May 20, 1996

TO ALL EXEC, EXEC 90 and EXEC 162F OWNERS

ADVISORY BULLETIN A-26

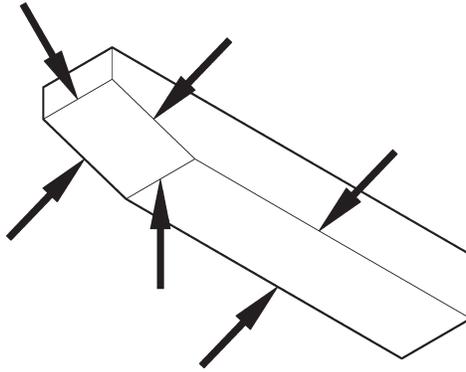
In addition, an inspection of the secondary shaft in the area of the keyway should be done every 100 hours. (If the aircraft already has more than 100 hours at this time, the inspection should be performed at the earliest convenience.)

The inspection consists of the following:

1. Remove the sprocket from the secondary shaft. This involves removal of the chain.
2. Thoroughly clean the secondary shaft with solvent and acetone to remove oil.
3. Use a penetrant inspection kit to detect any cracks. There are two kits available from Aircraft Spruce and Specialty:

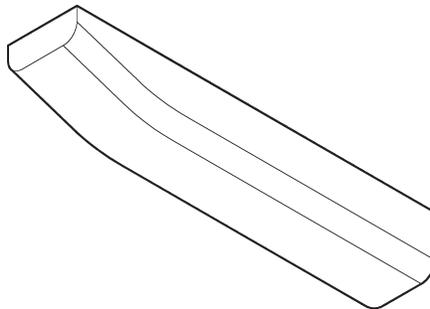
Another item of concern has been the installation of the key between the sprocket and the shaft. If the key is improperly installed, stress may be induced into the keyway area, which could develop into a crack.

Before re-installing the key, radius the edges of the key where it contacts the shaft, as indicated by the arrows in the illustration below. The edges should have approximately a 1/16" radius. This can be done using a file, grinder, or sander.
